#### DVD-Audio/Video and Super Audio CD Player

#### DVDS1500 service news

DVD-\$1500/DV-\$5770 (DVD-\$2500) DATE: April 2005 RELATED BULLETINNO: E-976

#### Disc Motor Noise

Old type FC08C

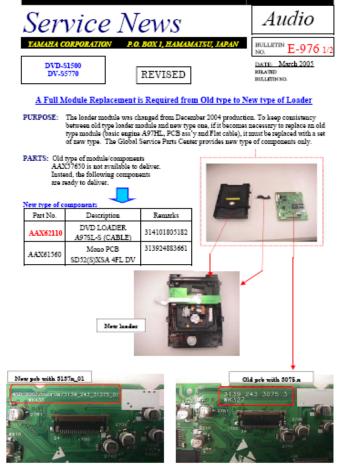
SYMPTOM: Although a very rare case, it appeared that a motor vibration noise in a unit when we play a

CD or DVD. The symptom is more likely to happen using an eccentric or unbalanced disc.

CAUSE: It occurs due to the production variations with the disc motors.

NOTE: You can confirm whether the motor is new or old by checking the label number on each

New type FC08K

SOLUTION: Replacing to a new improved motor will have less vibration.

When you check the disc motors for good or no good, you should play the 140cm eccentricity disc (TX911930) and check for the vibration noise.

Though the new type motors are used in the DVD-2500 from the beginning, the parts list in the service manual incorrectly shows the old part number. Please correct the part number.

## **DVD-S1500**

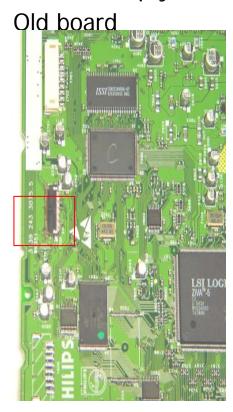
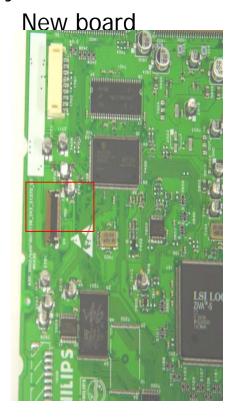
Please notice which board type you have by the laser flex connector on the board. Also checking the board no. located in front of the connector will help you distinguish which version you have.
